COMMUNITY DESIGN REVIEW BOARD STAFF REPORT

AGENDA ITEM: Woodspring Suites, 1744 County Road D East
a. Planned Unit Development and Lot Division Resolution
b. Design Review and Comprehensive Sign Plan Resolution

Engineering Plan Review**PROJECT: Woodspring Suites Hotel – 1744 County Road D****PROJECT NO: 20-20****COMMENTS BY: Jon Jarosch, Assistant City Engineer****DATE: 8-7-2020****PLAN SET: Engineering plans dated 7-24-2020
Stormwater Management Plan dated 7-27-2020**

WoodSpring Suites Elevations
MAPLEWOOD, MN

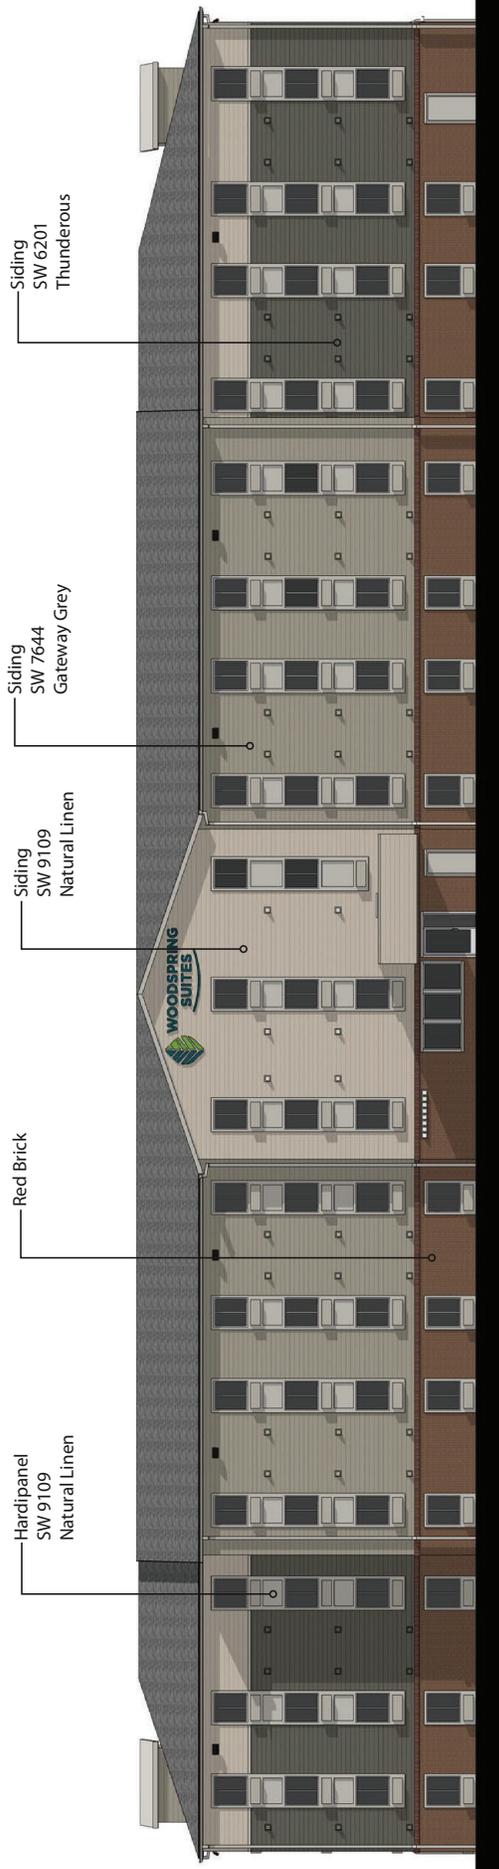
The height of the four-story building is 46' 10" – at its highest peak. The hotel building was designed to blend in with the nearby residential architecture. This building would have a pitched roof with asphalt shingles, the first floor would be covered with a brick facade and the remaining floors will be covered with lap siding. The lap siding would have three different colors.
